Product Change Notification

Change Notification #: 111933 - 00
Change Title: Intel® SSD 313 Series (20GB, 24GB, 2.5in)
PCN 111933-00, Label
Add Intel Return Address to SSD Label
Date of Publication: December 14, 2012

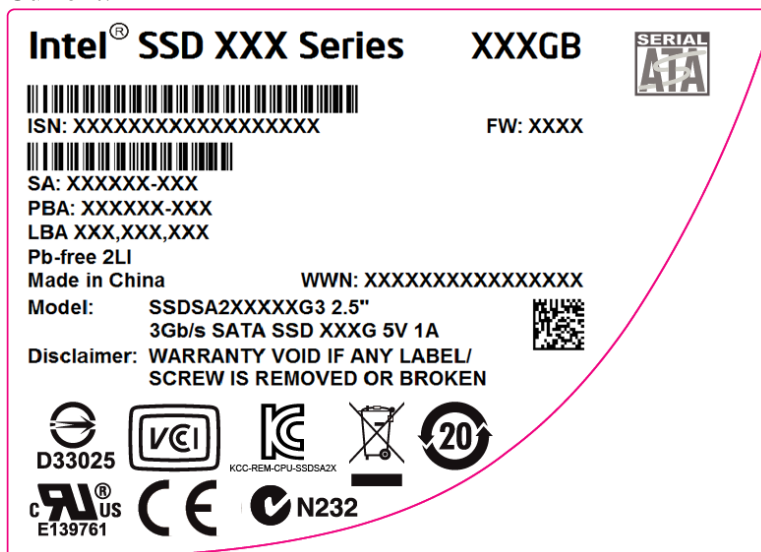
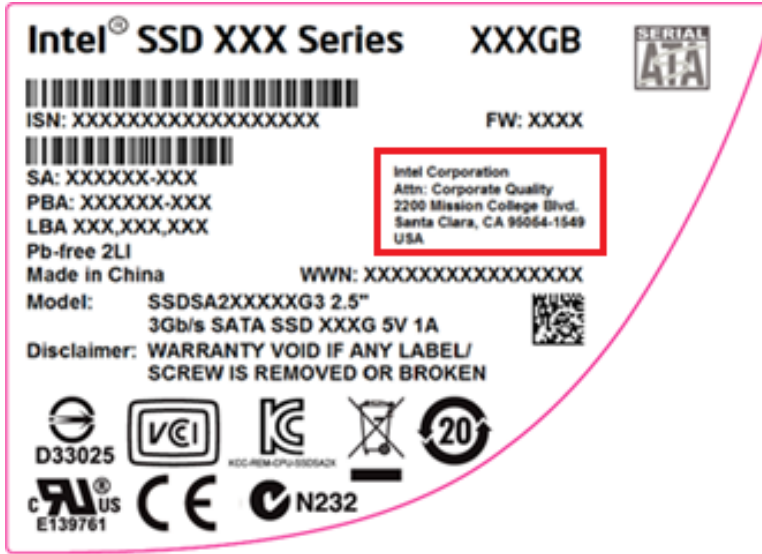
To meet EU regulatory requirements, Intel will be adding the Intel return address to the SSD label. See images below:
